# Land South of The Hill, Littlebourne: Response to KCC Consultation

Ref: VE/JW/ITM16283-011 TN

Date: 12 September 2023

**APPENDIX 1.A** KENT COUNTY COUNCIL  
CONSULTATION RESPONSE (16<sup>TH</sup>  
AUGUST 2023)

**Image 4.1: Traffic Assignment to/from Buff Road (Western Access) for Howe Barracks**

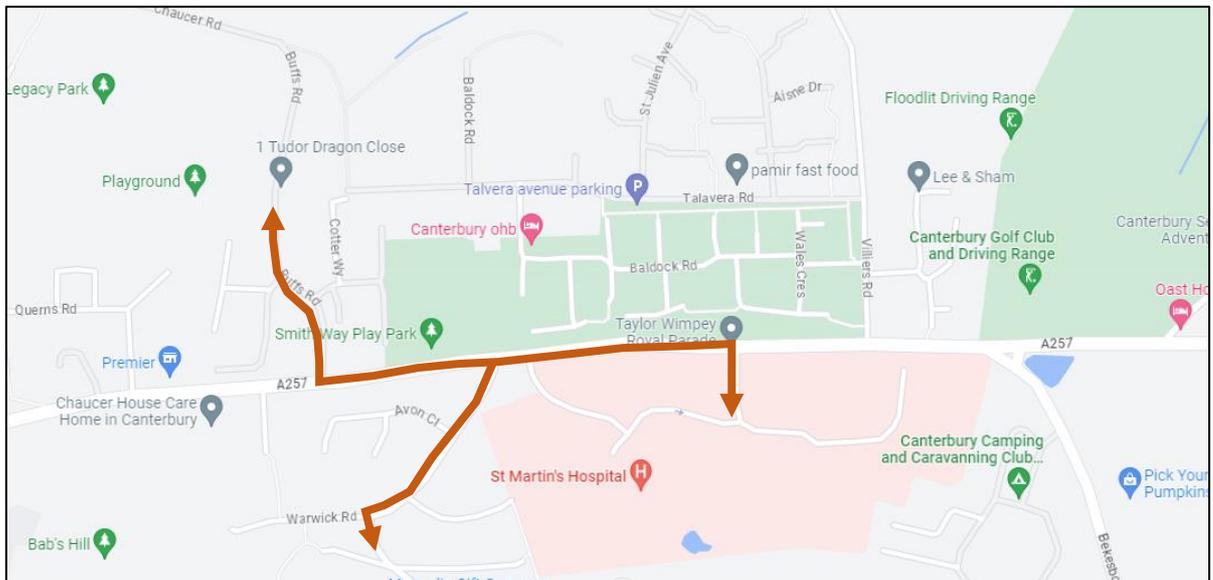
***"On assessing the flow diagrams for Howe Barracks, there were some figures that require clarification, as highlighted below. These do not appear to correspond to other figures used within the flow diagram."***

- 4.2 The traffic flows for Howe Barracks were taken from the Transport Assessment produced by PBA in June 2014 for the planning application (CA/14/01230/FUL). These traffic flows are stated to be presented in Figure 6.1 and 6.2, for the AM and PM peak respectively. It is noted that in the appendices to the PBA report these are both referenced as Figure x.x.
- 4.3 Howe Barracks is served from two access on the A257 as shown on the traffic flow diagram presented in i-Transport’s previous response to KCC’s comments (ITM16283-010 - Appendix 4.D) – these are represented by Buffs Road to the west and Villiers Road to the east on the map below.
- 4.4 The traffic routing assignment presented in the PBA report shows that all traffic leaving the Buffs Road to/from the east would travel to/from Warwick Road and/or the hospital site, as shown on the plan below.

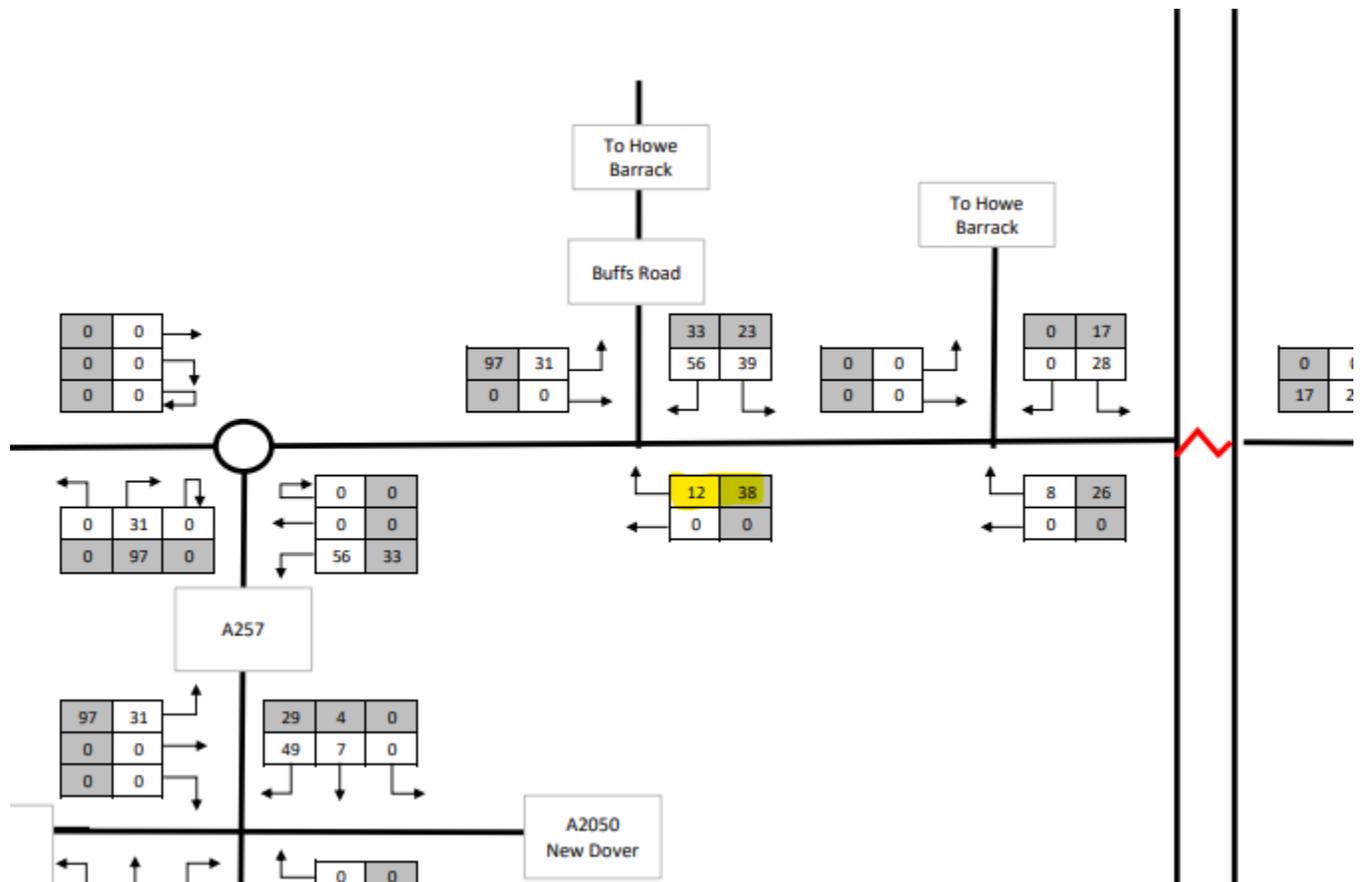
Having assessed the submitted traffic survey data, I concur that the traffic flows recorded via the ATC placed on The Hill validate the one day manual turning count figures that have been used.

As such we are minded to accept the manual turning count figures as surveyed.

**APPENDIX 4.A** HOWE BARRACKS COMMITTED  
DEVELOPMENT TRAFFIC FLOWS

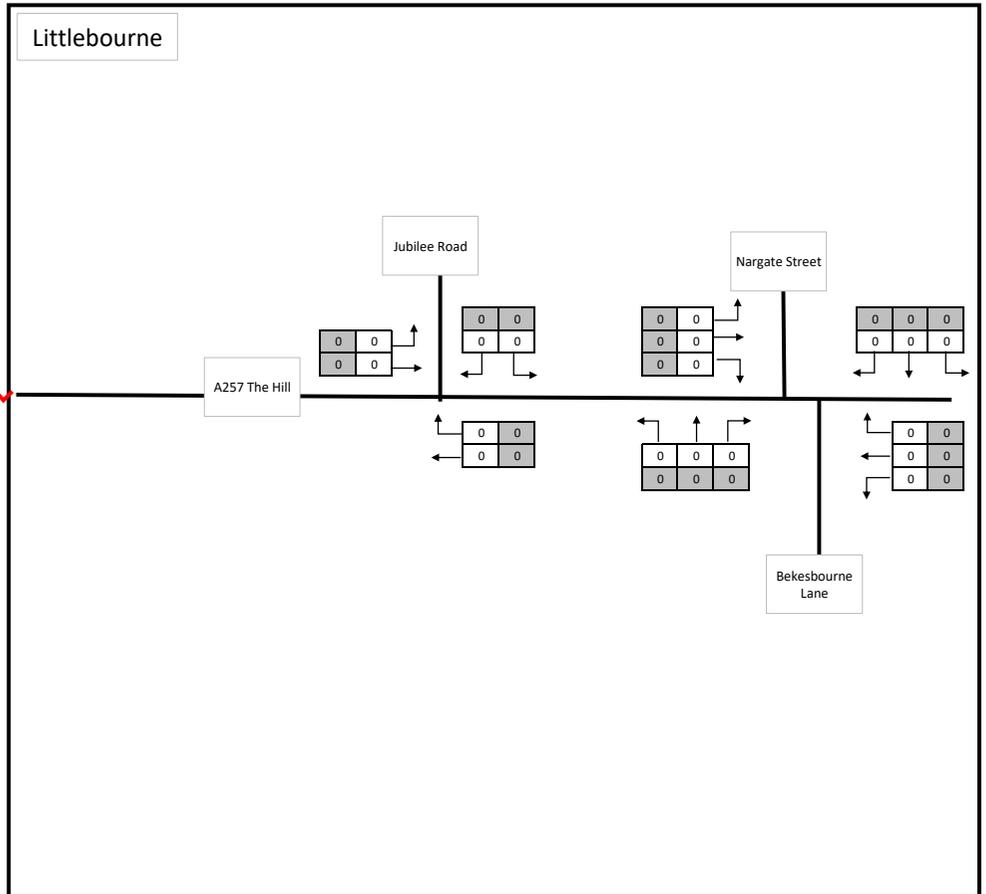
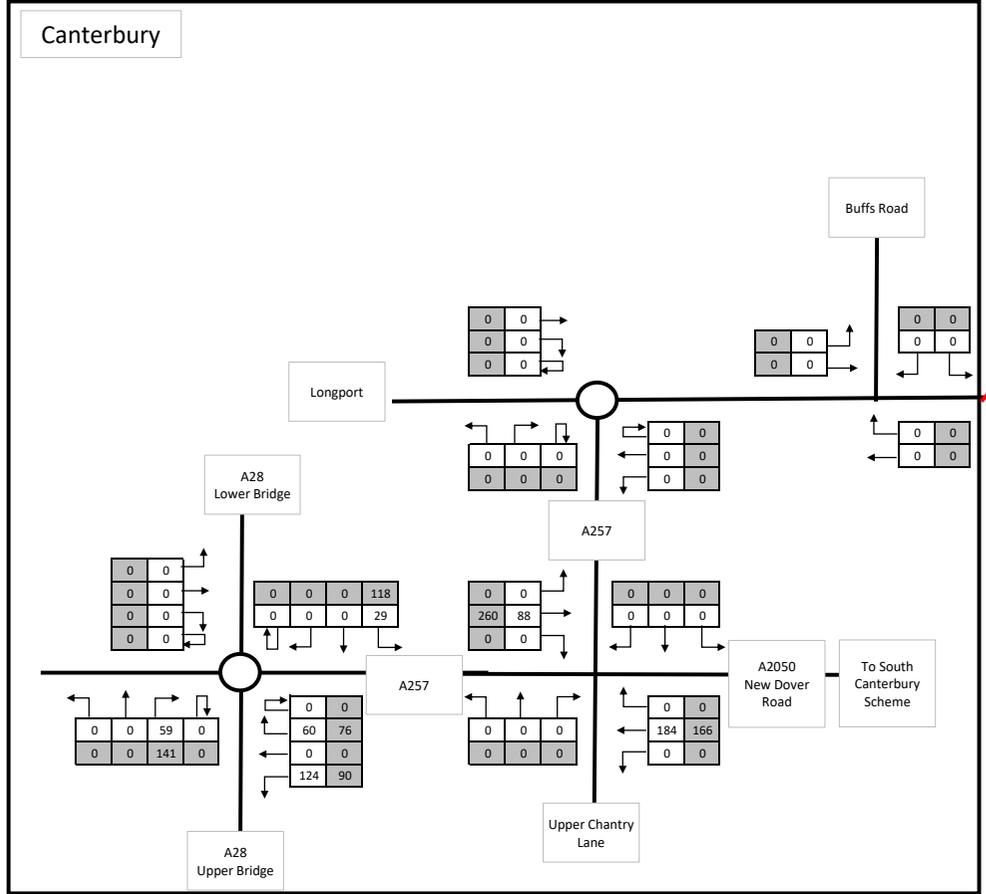
On assessing the flow diagrams for Howe Barracks, there were some figures that require clarification, as highlighted below. These do not appear to correspond to other figures used within the flow diagram.

- 4.6 This therefore explains why some of the traffic flows on the i-Transport traffic flow diagrams appear to disappear between the two access points.
- 4.7 Traffic flows associated with Bokesbourne Lane had been omitted at the eastern site access, as they did not impact on any of the assessment junctions. The corrected traffic flow diagram for the Howe Barracks trip generation, including the traffic flows associated with Bokesbourne Lane, are presented in **Appendix 4.A** of this note.

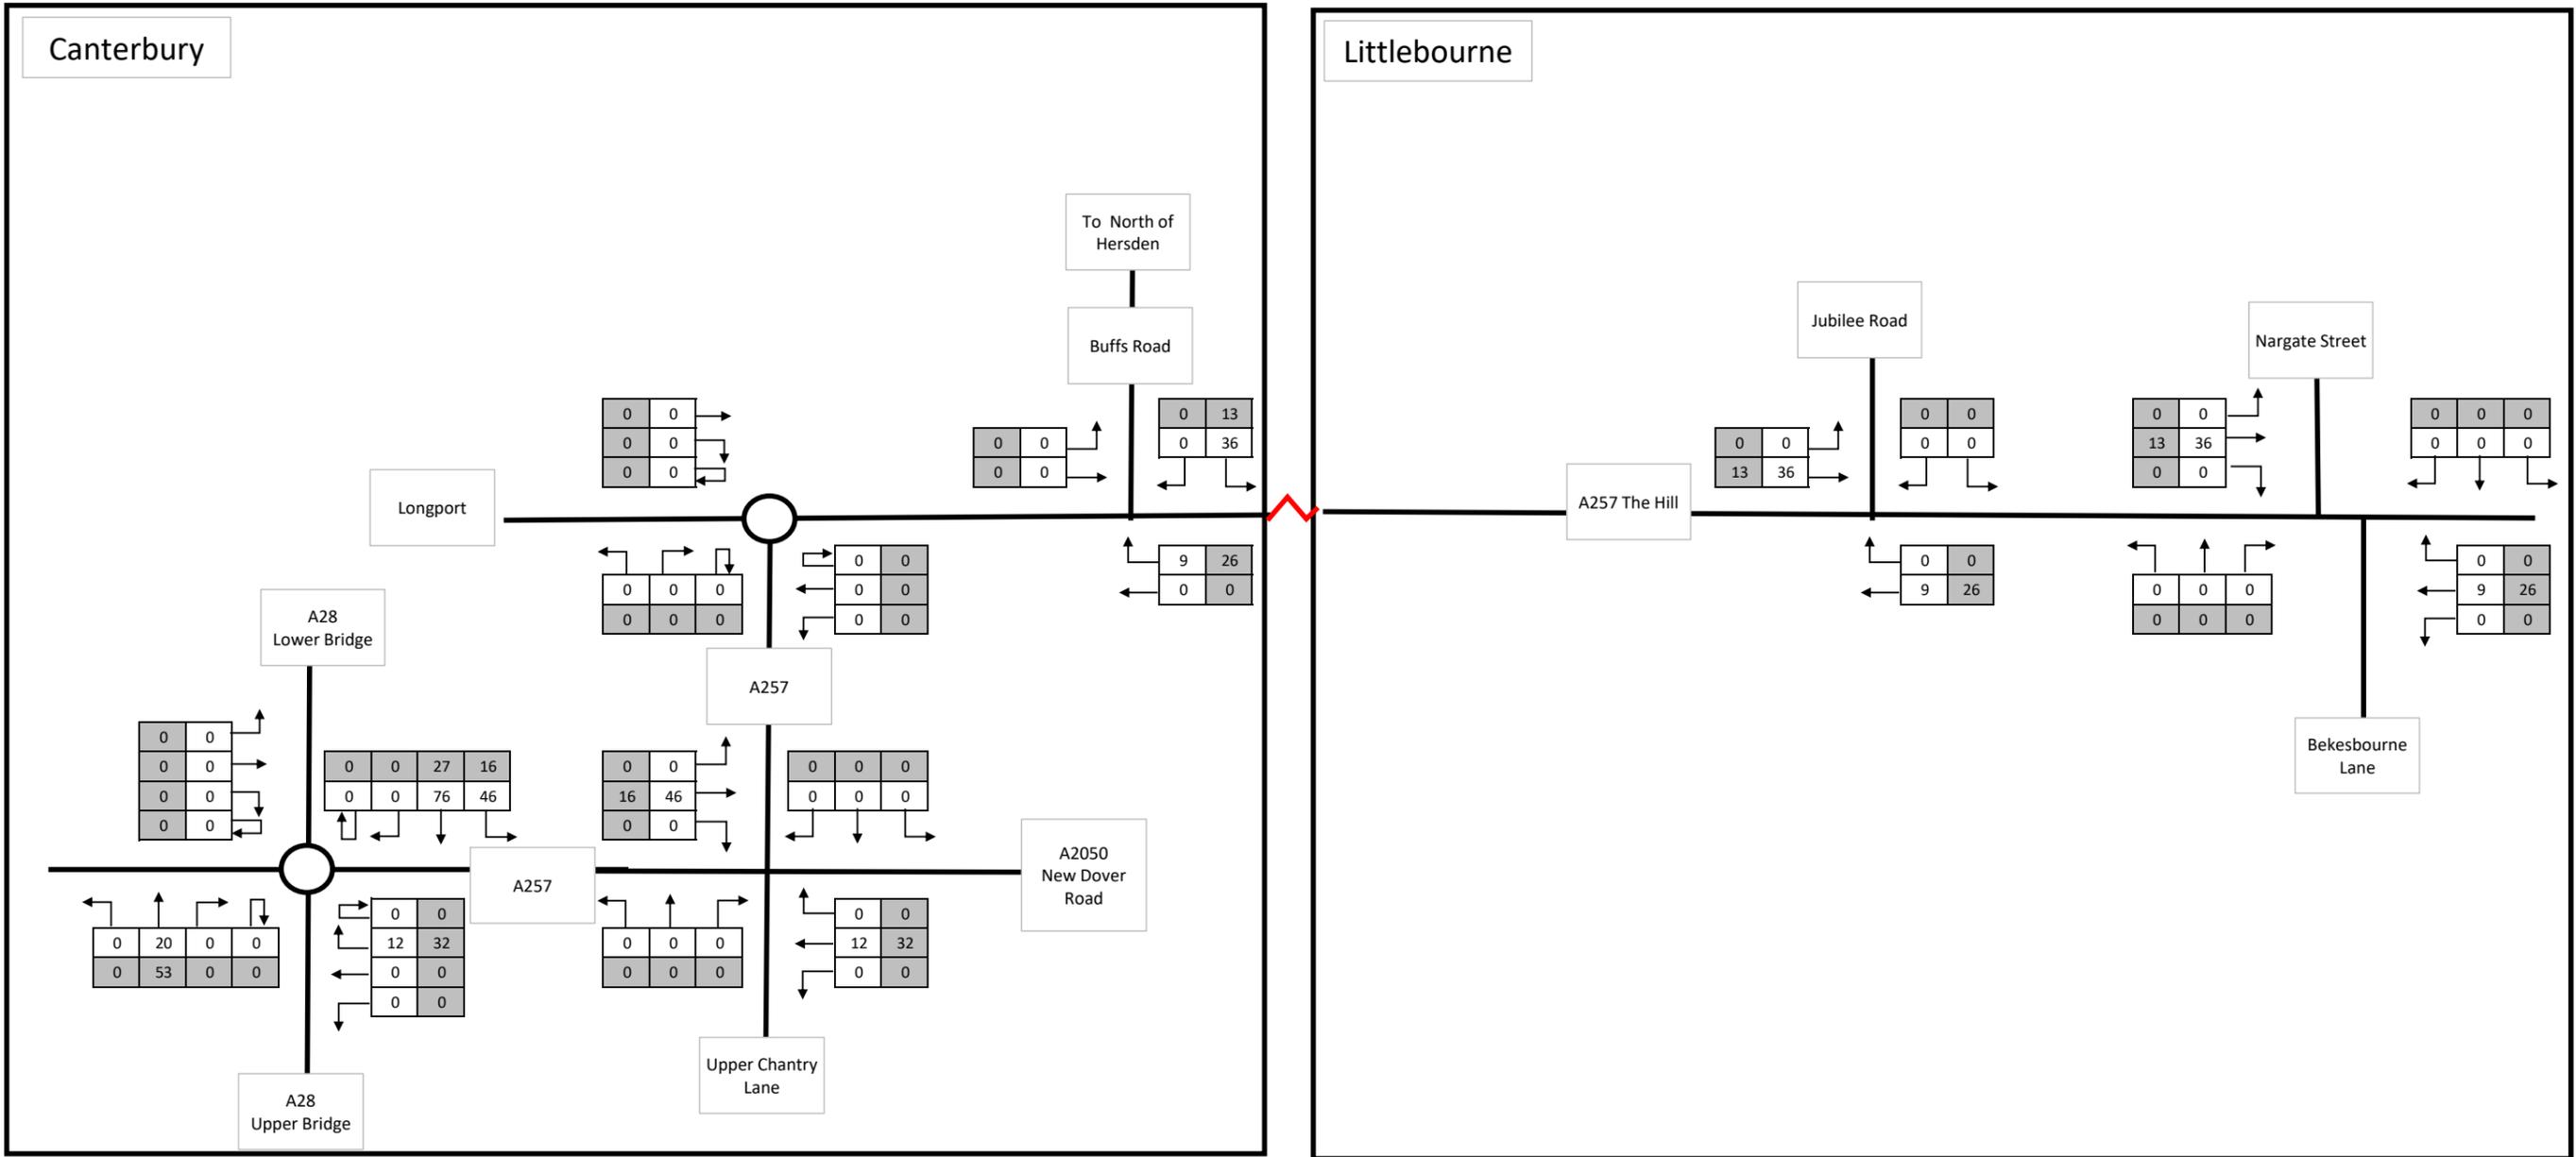
***“When assessing the total flows on Appendix 4.E-5, the figures do not correspond to those shown in 4.E-1 to 4.E-4. Can these please be reviewed.”***

I also have queries regarding the flow diagrams for the Canterbury South Application. When assessing the total flows on Appendix 4 E-5, the figures do not correspond to those shown in 4 E-1 to 4 E-4. Can these please be reviewed.

- 4.8 A typographical error has been noted in the traffic flow diagrams associated with the P&R element of the site (previous Appendix 4.E-3), in the PM Peak hour. These have been corrected, along with the total development traffic flows. The corrected South Canterbury traffic flow diagrams are included in **Appendix 4.B**. This results in minor changes in the overall committed development traffic flows, which are taken into account in the development impact assessment set out in Section 5 below.
